THE ILLINOIS STATE TOLL HIGHWAY AUTHORITY

BASE SHEETS

ESC (200), RDY (400), BRG (500), DRN (600), MOT (700), OHS (720)

PART 1 of 2

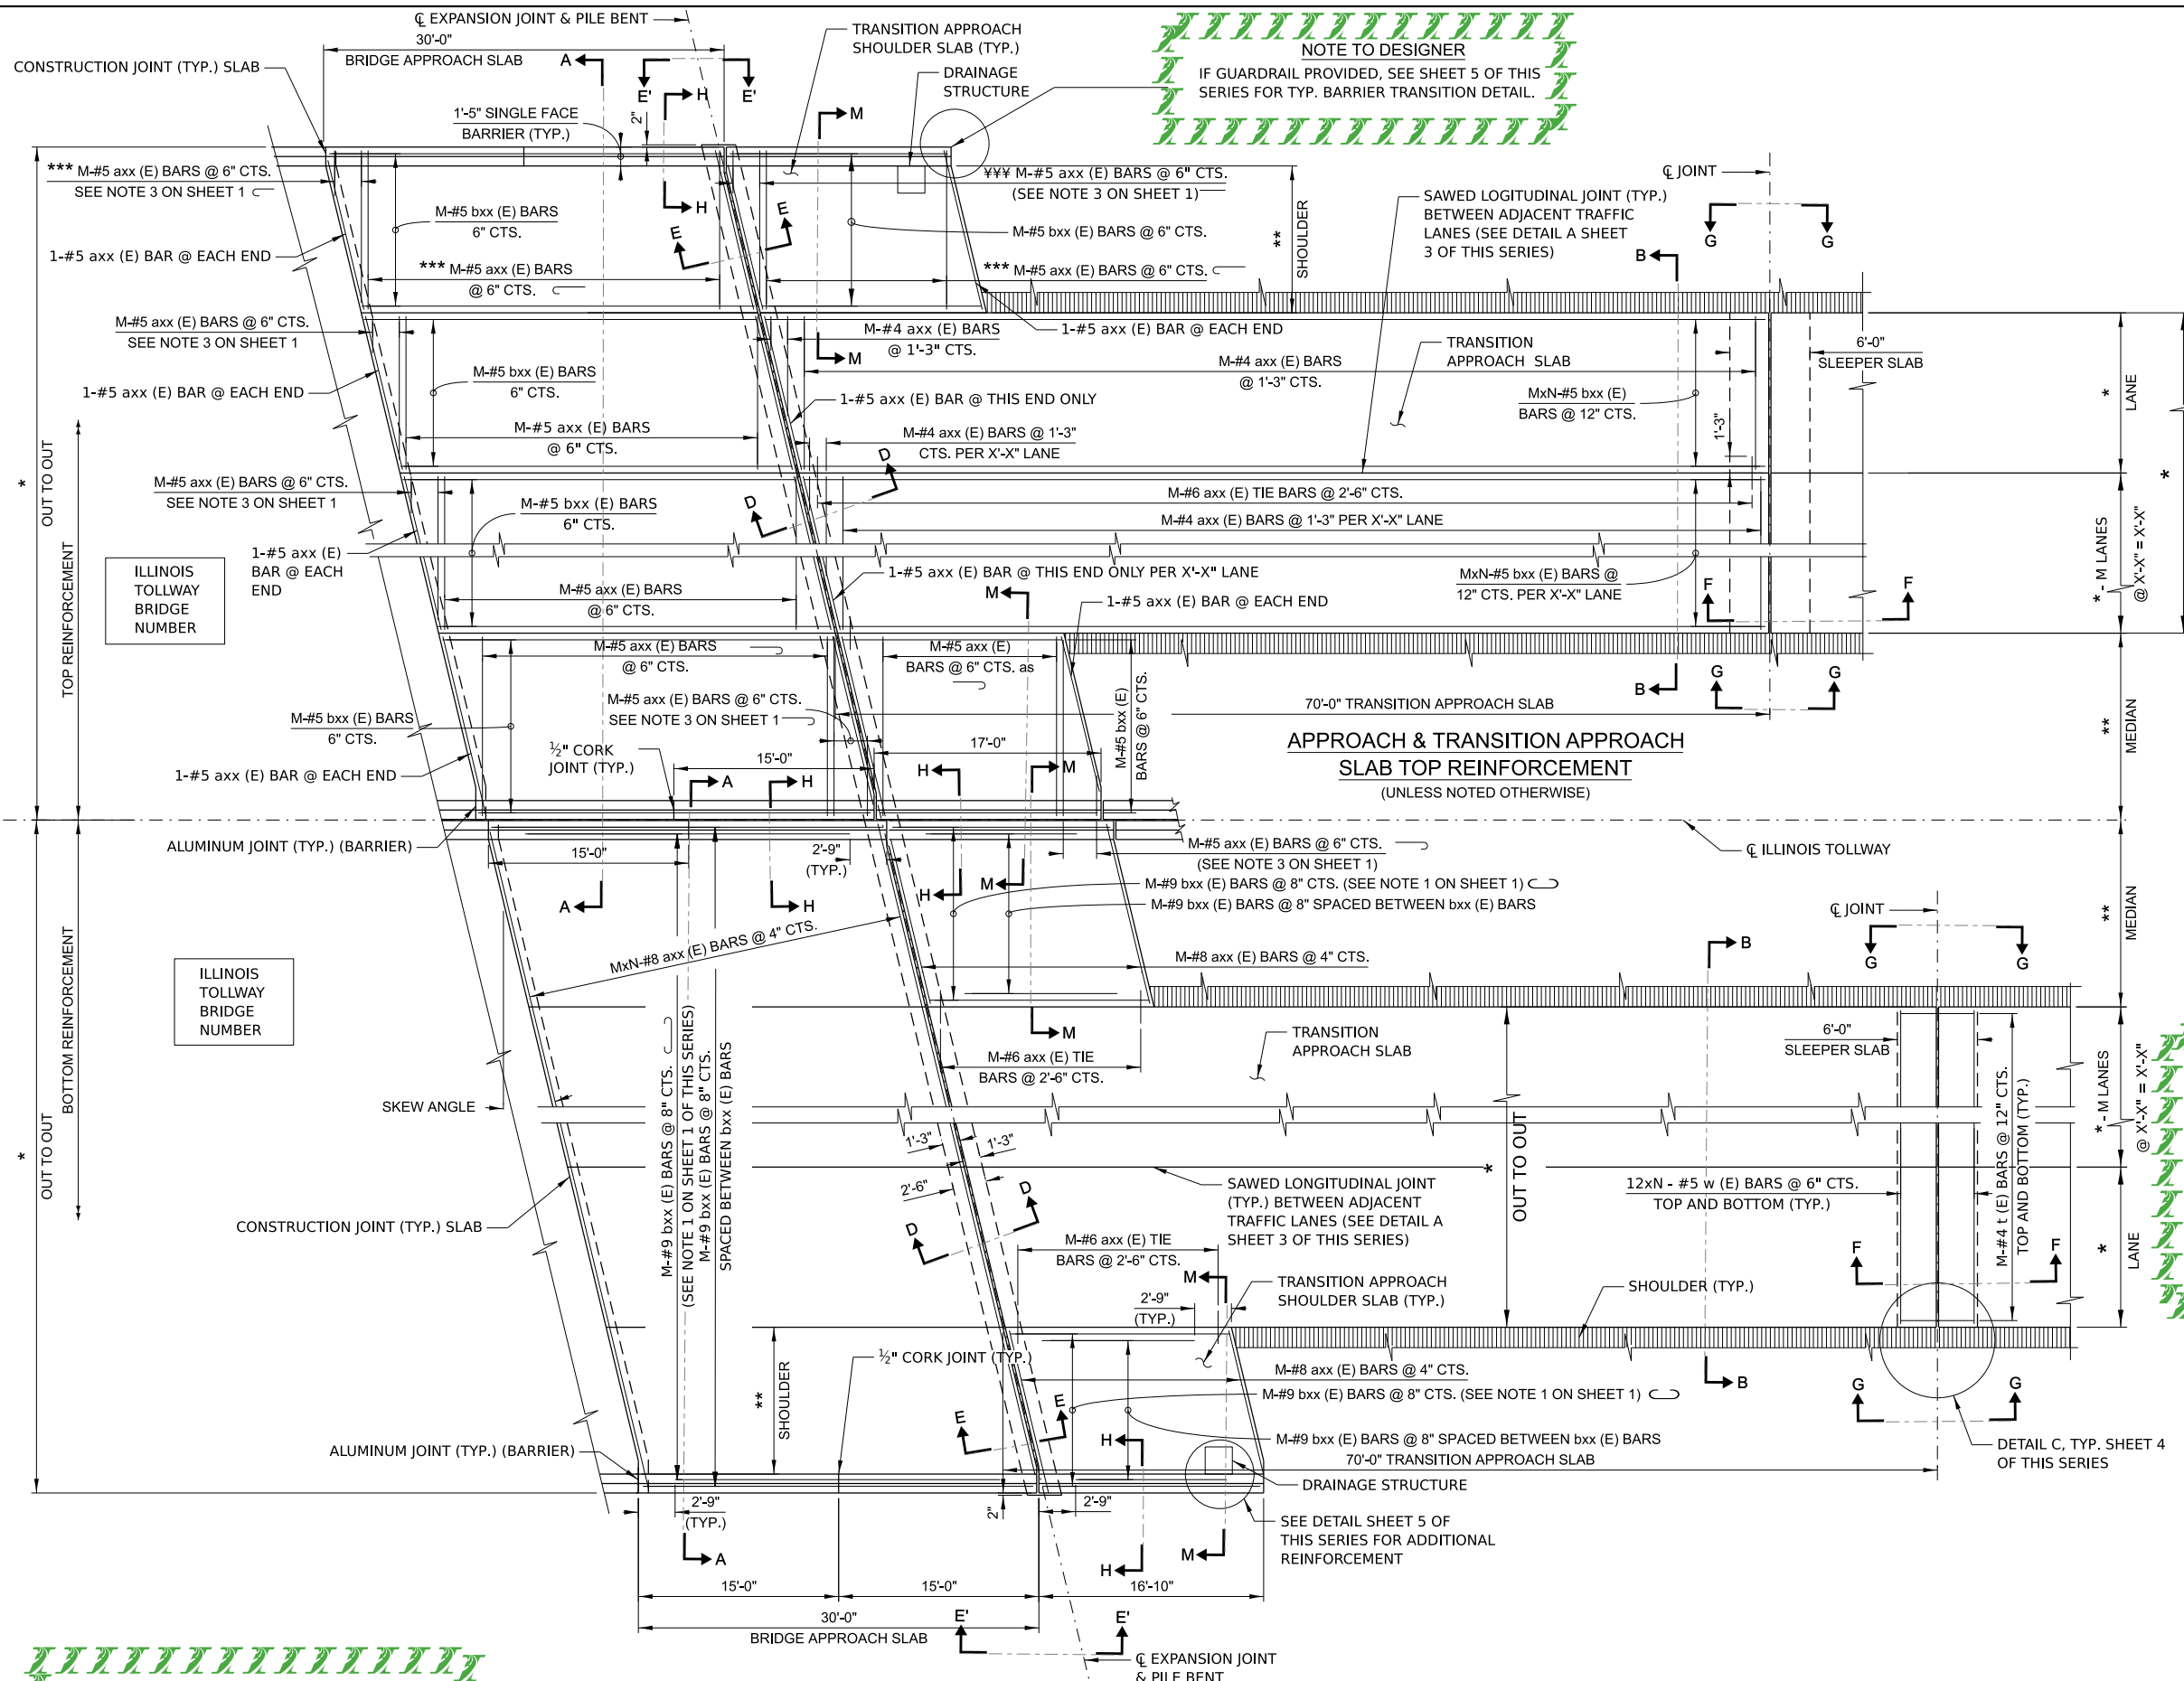
Sheet 1	Revised 'Note 1' clarifying the 3'-0" shelf requirement in cut condition.		
M-RDY-407	EARTHWORK SCHEDULE		
Sheet 3	Added note in 'Note to Designer' for the Non-special waste disposal quantities calculations for contracts with over 1000 cubic yards of Type 1C and Type 1B		
M-RDY-407	GUARDRAIL SCHEDULE

Sheet 4	Revised 'Note to Designer' to state that 9 foot post is no longer used for Tollway contracts. Removed columns for 9 feet post from 'Guardrail Schedule' table to reflect the change.		
M-RDY-408	APPROACH SLAB, MAINLINE

VERSION: 2026-03 BASE SHEET: M-RDY-408 SHEET: 5 OF 5

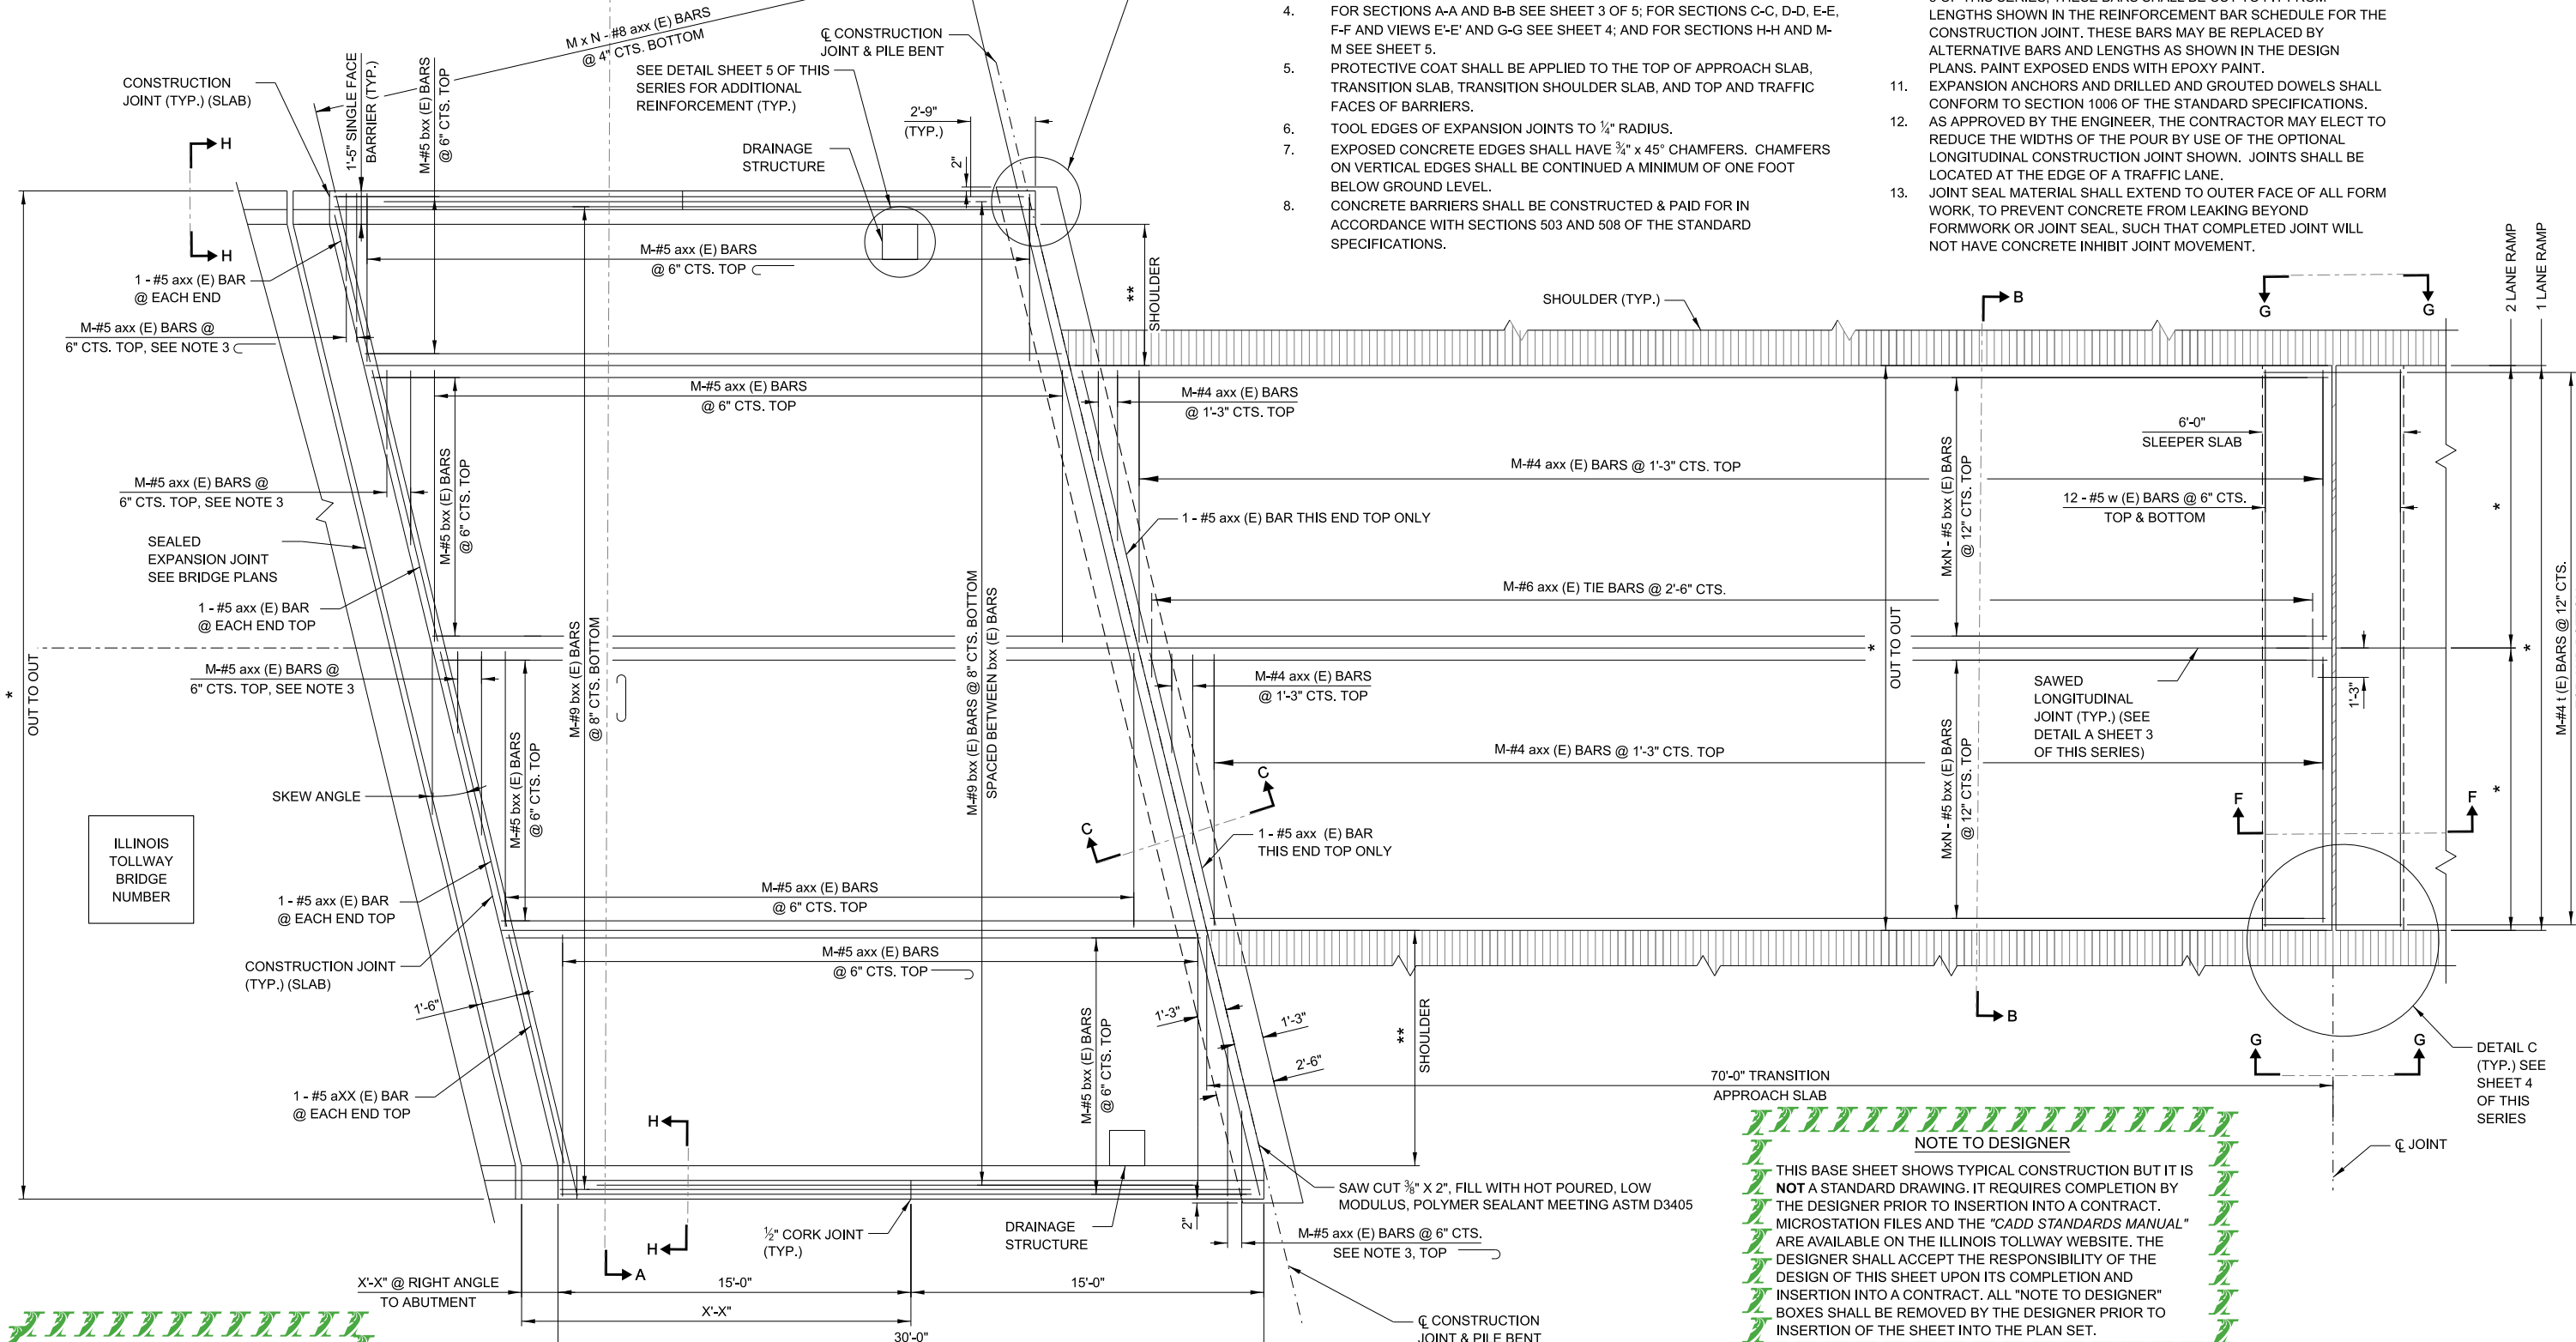
Sheet 1	Note 2 is revised to refer the latest updates from 'IDOT Bridge Manual' (2025)		
Sheet 3	Added call out 'Subgrade Filter Fabric' and deleted 'Porous Granular Backfill' in the 'Longitudinal Cross Section' detail.

Sheet 4	Revised 'Section F-F' and added 'Note to Designer' to show milling and overlay if proposed pavement is composite pavement.		
M-RDY-409	APPROACH SLAB, RAMP

APPROACH SLAB, RAMP

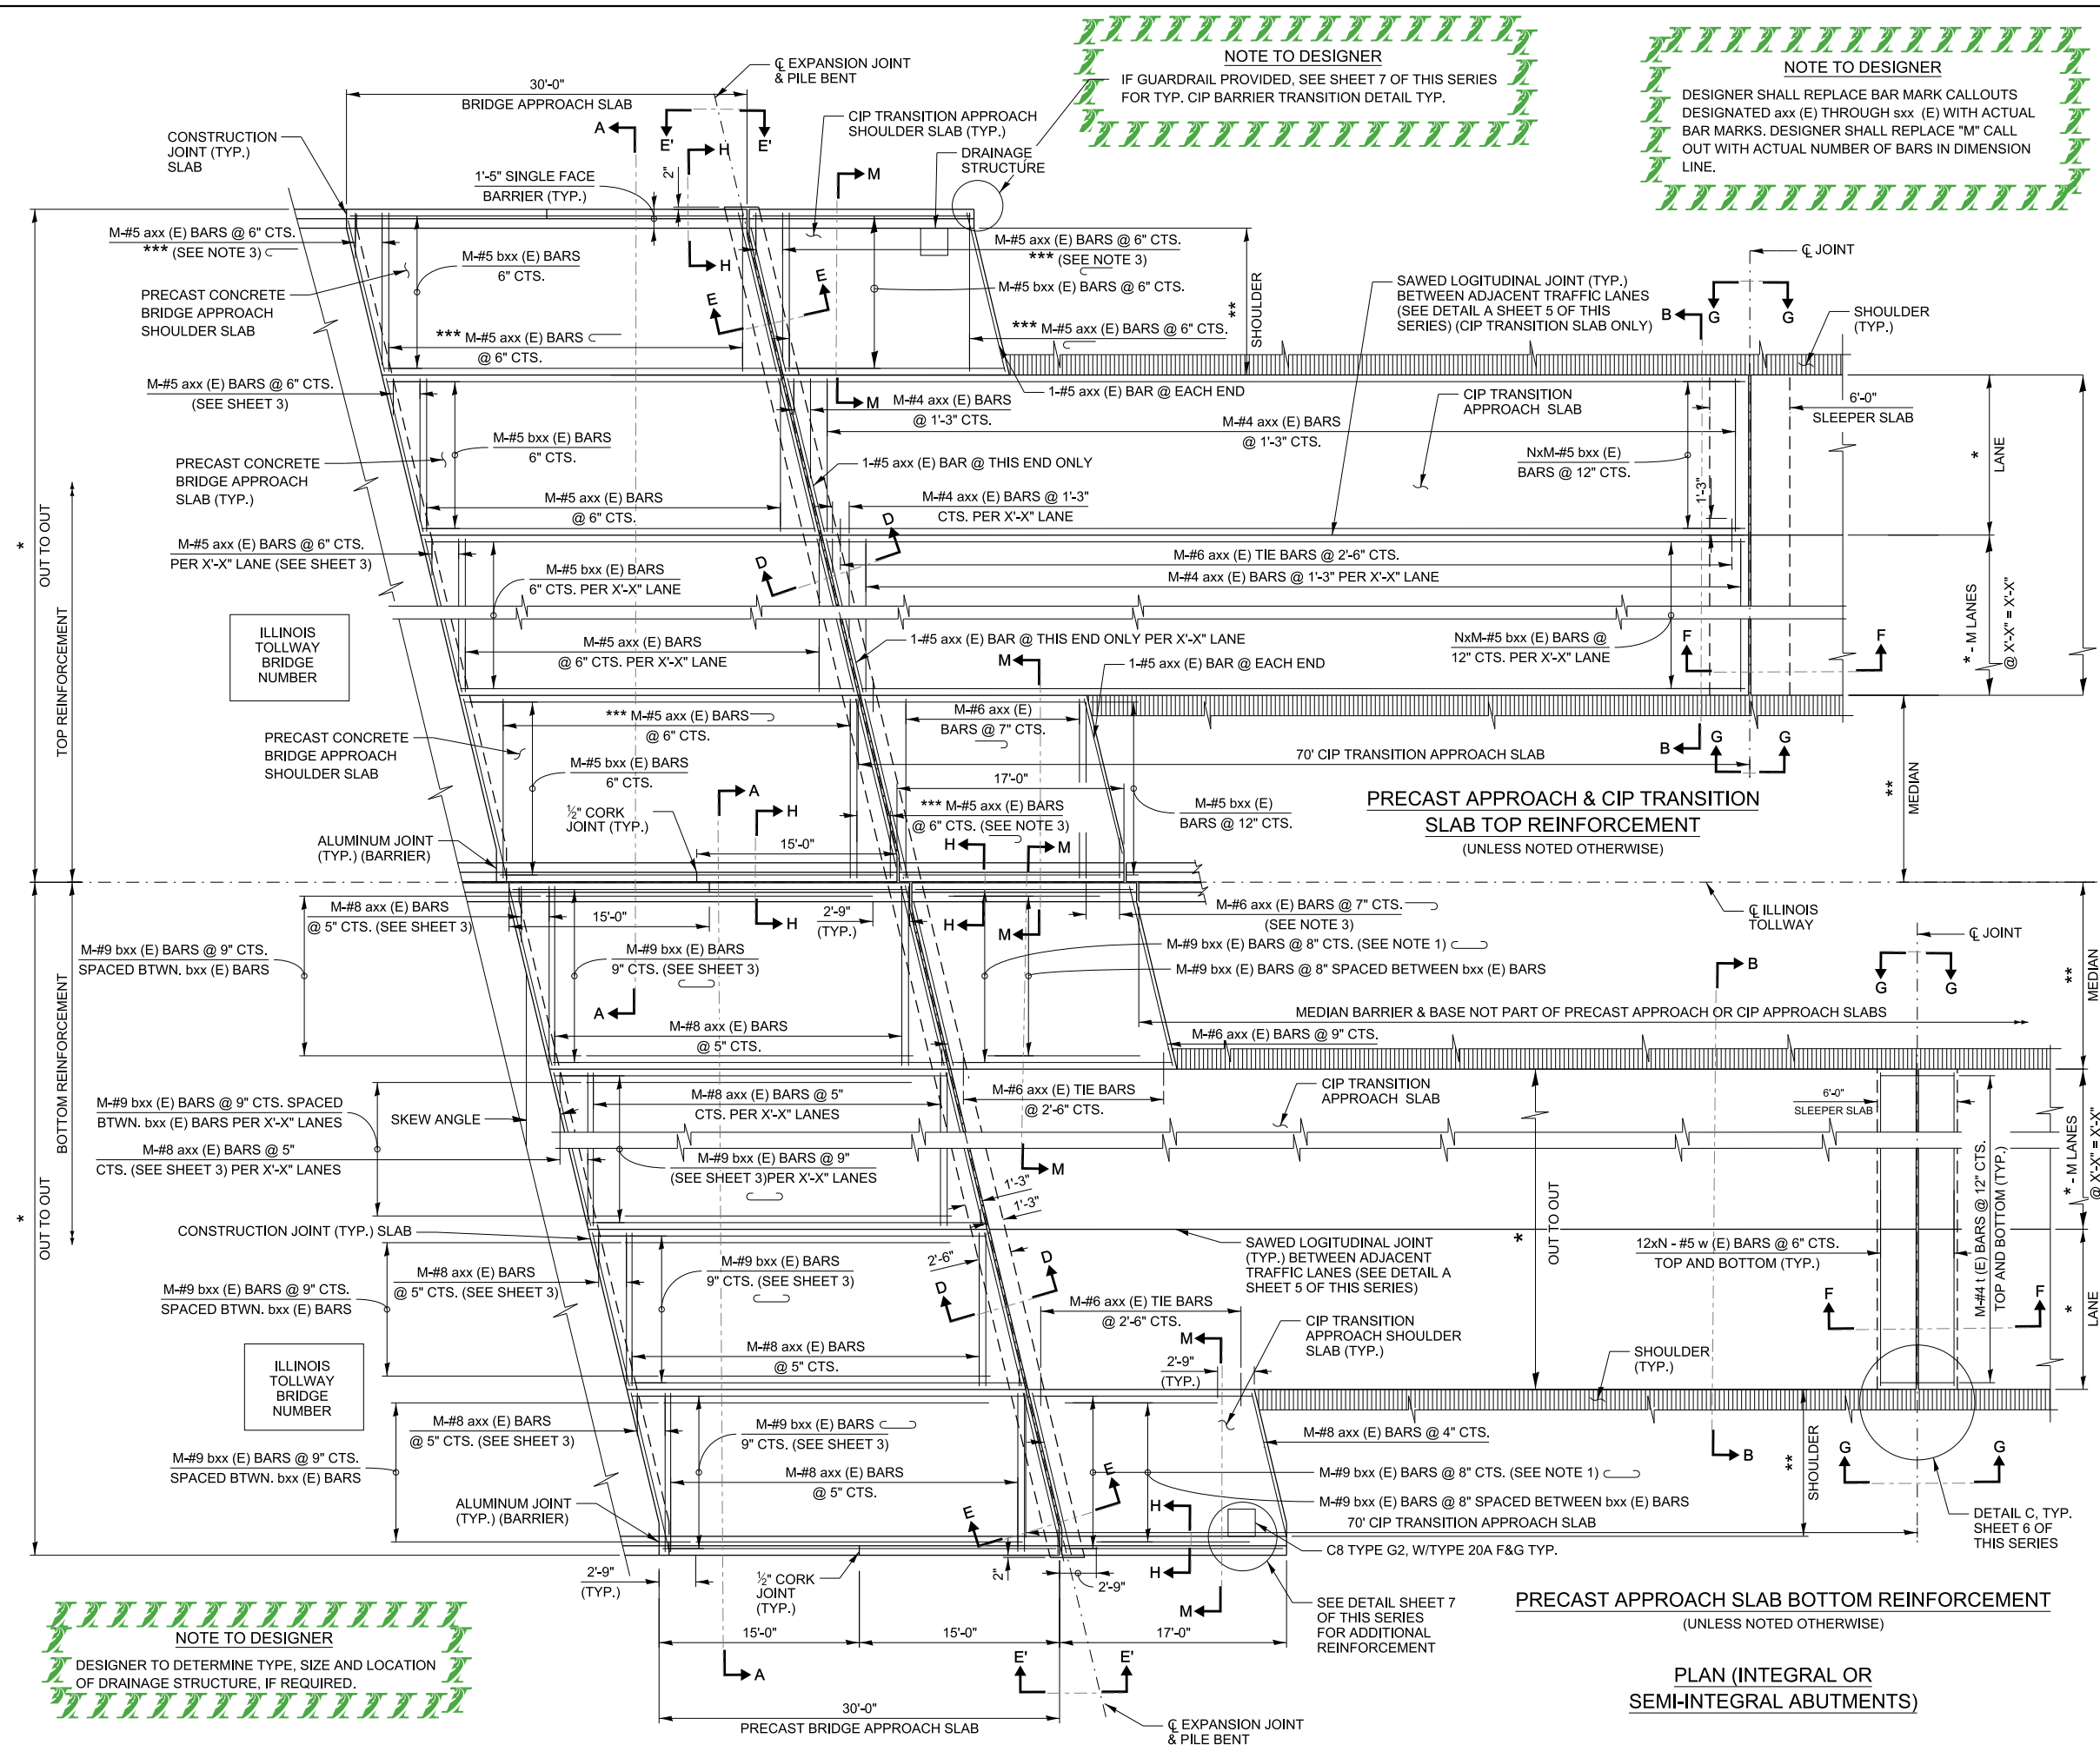
Sheet 1	Note 2 is revised to refer the latest updates from 'IDOT Bridge Manual' (2025)		
Sheet 2	Deleted anchor rod holes at pile cap in 'Precast Bridge Approach Slab Layout'.

Sheet 3	Deleted 'Porous Granular Backfill' in the 'Longitudinal Cross Section' detail.		
	Added rebars at closure pours in 'Section A-A'.		
Sheet 4	Updated bar list table.

Sheet 4	Added rebars at closure pour in 'Detail H'.		
Sheet 6	Revised 'Section F-F' and added 'Note to Designer' to show milling and overlay if proposed pavement is composite pavement.
